# Access Compliance Report

## Public Rights-of-Way

Intersection ID: 23447	Main Street: BRACKENBURY_LN	Cross Street: ALEXANDER_RD	Location: SW
ADA ID: 55F07BA1B7A9	Ramp Type: Perp	Initial Pass/Fail: Fail	Overall Compliance: No
		Severity Score: 8.75

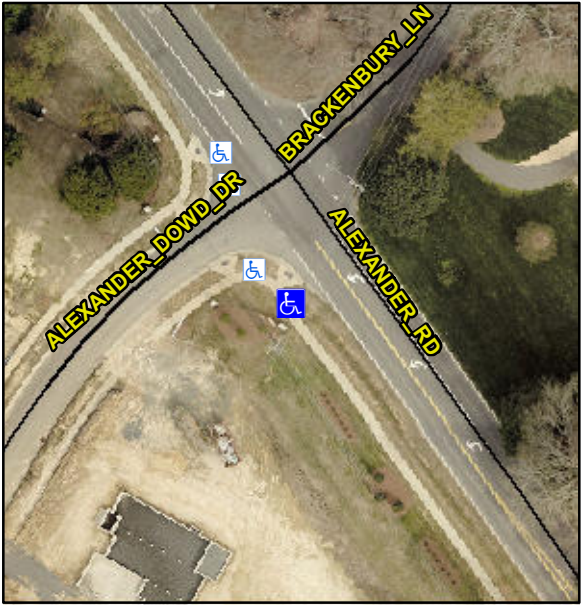
Codes/Mitigation Info/Possible Solution		Field Measurements/Component Compliance			
	Possible Solutions:				
	Remove & Replace Entire Ramp.				
	Surveyor Notes:				
	N/A				
	PROW/ADA:				
	R304.5.1				
Street 1 Name	ALEXANDER RD				
Stop Condition-Street 2	None				
Street 2 Name	N/A				
Stop Condition-Street 1	N/A				
Total Cost:		\$	1850.00

Compliance	Description	Data	Compliance	Description	Data
N/A	Ramp Length (in)	29.0	Yes	Ramp Slope (%)	5.2
No	Ramp Width (in)	46.5	Yes	Ramp XSlope (%)	1.8
N/A	Flare Type LT	N/A	N/A	Flare Type RT	N/A
N/A	Flare Slope LT (%)	N/A	N/A	Flare Slope RT (%)	N/A
N/A	Flare Traversable LT?	N/A	N/A	Flare Traversable RT?	N/A
N/A	Landing Length (in)	N/A	N/A	DWS Provided?	N/A
N/A	Landing Width (in)	N/A	N/A	DWS Contrast?	N/A
N/A	Landing Slope (%)	N/A	N/A	DWS Length (in)	N/A
N/A	Landing X Slope (%)	N/A	N/A	DWS Full Width?	N/A
N/A	Landing Curb? (Y/N)	N/A	N/A	DWS Offset (in)	N/A
N/A	Shared Landing?	N/A			
N/A	Gutter Ponding?	N/A	N/A	Gutter Slope (%)	N/A
N/A	Gutter Lip Ht (in)	N/A	N/A	Gutter X Slope (%)	N/A
N/A	Painted X Walk1?	No	N/A	Painted X Walk2?	N/A
	X Walk 1 Direction	To NE		X Walk 2 Direction	N/A
N/A	X Walk 1 Width (in)	N/A	N/A	X Walk 2 Width (in)	N/A
	X Walk 1 Slope (%)	3.6		X Walk 2 Slope (%)	N/A
	X Walk 1 X Slope (%)	2.4		X Walk 2 X Slope (%)	N/A
